SUNDRY NOTICES AND REPORTS ON WELLS

Well No. 4-26 is located 1850 ft. from [N] line and 790 ft. from [E] line of sec. 26SE/4 Sec. 26 26N 4W NMPM
(1/4 Sec. and Sec. No.) (Twp.) (Range) (Meridian)Tapacito Pictured Cliffs Rio Arriba New Mexico
(Field) (County or Subdivision) (State or Territory)The elevation of the derrick floor above sea level is 6954 ft. GL
6966 KB

Well Location and Acreage Dedication Plat

Operator CONSOLIDATED OIL AND GAS, INC. Lease LOWE 4-26
 Well No. _____ Unit Letter I Section 26 Township 26 NORTH Range 4 WEST NMPM
 Located 1850 Feet From the SOUTH Line, 790 Feet From the EAST Line
 County RIO ARriba G. L. Elevation 6954.0 Dedicated Acreage 160 Acres
 Name of Producing Formation Pictured Cliffs Pool Tapacito

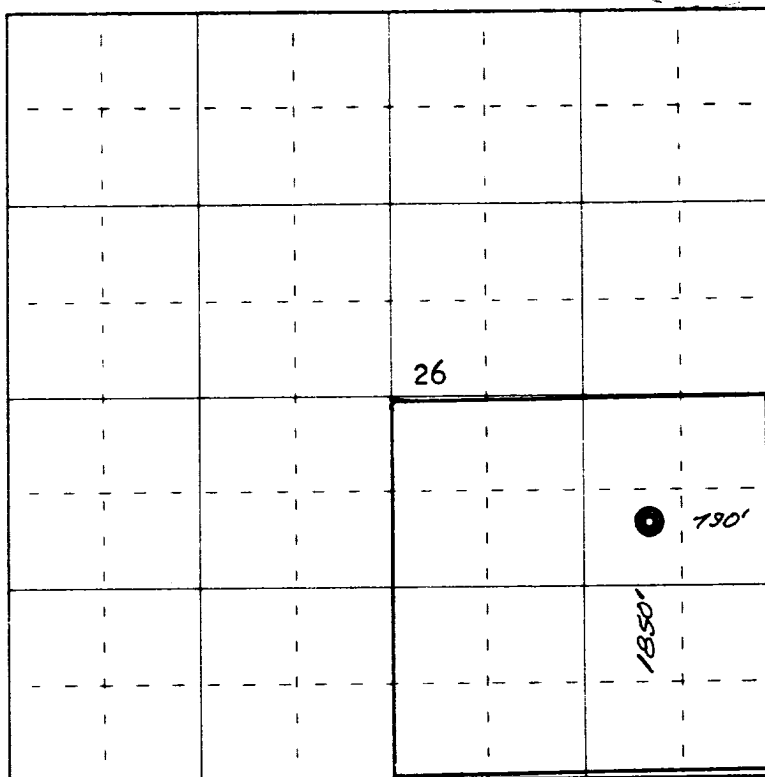
This form is being resubmitted to show change in location from 1800' south, 790' east of Section 26, T26N, R4W to 1850' south and 790' east of Section 26, T26N, R4W. The previous form was submitted on October 25, 1963 and approved October 28, 1963.
